Tight rig verification Borgland Dolphin

DNO Norge AS, Wellesley Petroleum AS,
and INEOS E&P Norge AS

AUDITEE Dolphin Drilling/Borgland Dolphin		DATE 12/04/2021	
AUDIT NO. EA-2021-1		REV.NO. 01	
DOCUMENT APPROVAL			
	Name:	Date:	Signature:
Prepared by:	Anniken B. Meisler	06/04/2021	Anniken B. Meisler
	Christina Rødne	06/04/2021	C.S. Rødne
Approved by:	Stig Seland	12/04/2021	Stig Seland

Figure 4-1: UHG seen from above, looking at sea

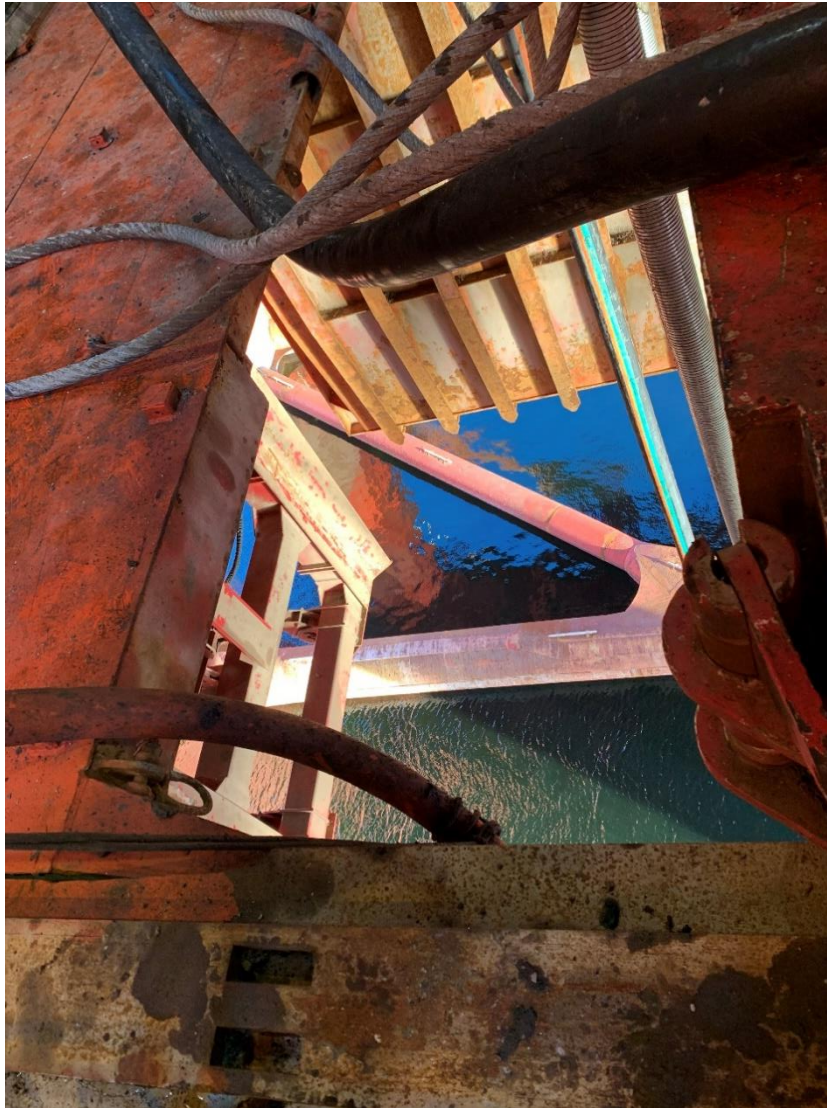
The general impression among the rig crew was that the chemical used in the Under House Guide (UHG) and riser tensioner – Houghto-Safe NL-1 - is an environmentally friendly glycol. This is a chemical categorized as red.

The verification team recommend to inform relevant crew on this misunderstanding, and BGL to also look for possibilities for substituting this chemical. Any leakages from the UHG (see Figure 4-1) or riser tensioner will go directly to sea, so using a more environmentally friendly alternative would be beneficial. But the most important is the security of rig and equipment, so it is recommended to start the process with securing that this chemical

Figure 4-5: Left- open drain #174. Right – Drain overview in Control room. Red dots indicate open drains.

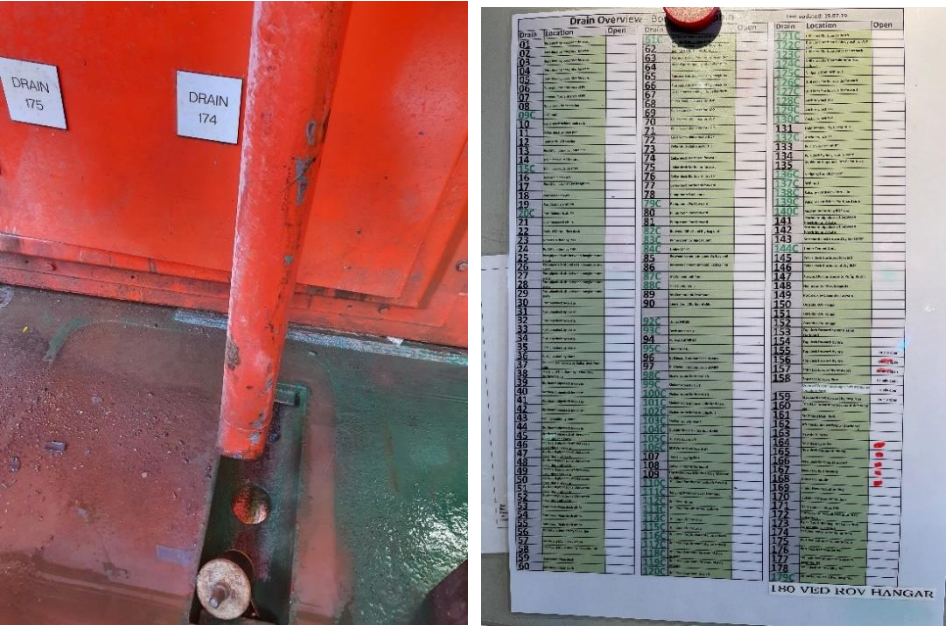
Drain #174 outside pump room was open due to washing, see Figure 4-5. CRO was not informed. This is a deviation from given requirements, ref. /5/. Requirements states that drains can be opened for a short period without informing CRO if person stay by the drain until closed.

Cleaning was ongoing, but no one was seen close to the drain. The verification team contacted the CRO and the drain was not marked as open on the drain overview in Control room (Figure 4-5). The team passed the drain several times during a 4-hour period, and the drain was still open.

If open drains are found without supervision, or not registered as open by the CRO, tends to be a problem, the verification teams suggests that the guideline ST-0104 is changed and no drains can be opened without informing CRO.

Figure 4-6: Left – Missing label for Fuel oil at starboard hose station. Right - Missing labels for WBM and Brine at port hose station

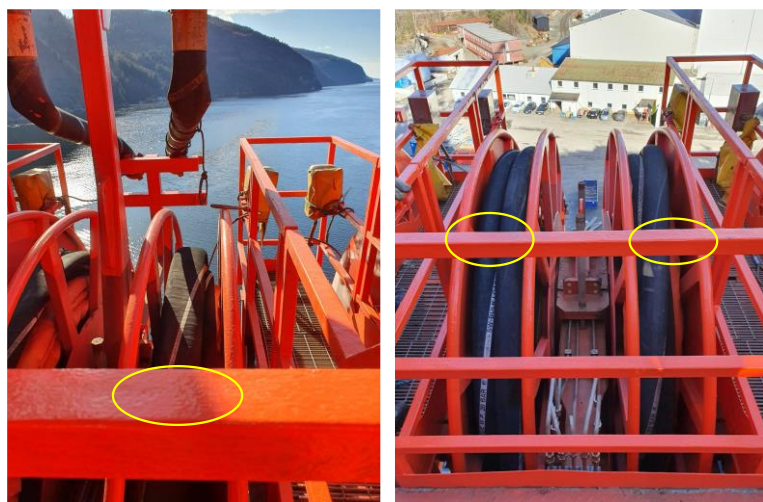
Some labelling/markings were missing at the hose stations (Figure 4-6). At starboard hose station label were missing by the fuel oil hose, while on port hose station labelling was missing for both WBM and Brine.

It was not particularly easy to follow the hoses further inwards in the rig to see what type of fluid the hoses should load/unload. It is therefore recommended to mark the hose reels so that no misunderstanding or errors can occur.

Figure 4-9: Missing sealing (to the left) and inventory list and lacking equipment (right)

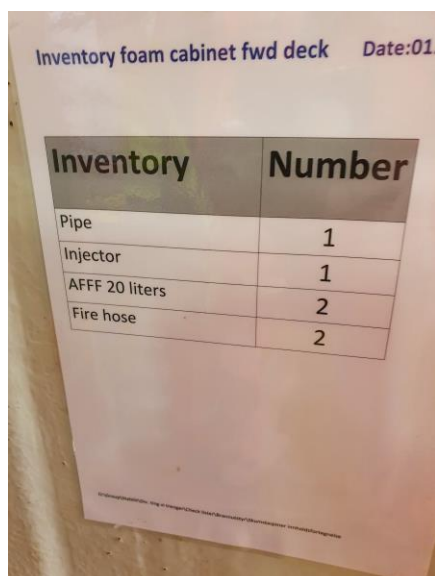
An inspection of SOPEP equipment revealed that two of the SOPEP boxes on starboard side missed sealing and one was half full. Inventory lists were also missing in the boxes. See Figure 4-9.

The verification team recommends BGL to go through the open boxes, fill them up with needed equipment, put up Inventory list, and then seal them off. Since there is uncertainty regarding inventory lists in the other four boxes, these should also be checked. This to secure that all expected equipment is available in these boxes.
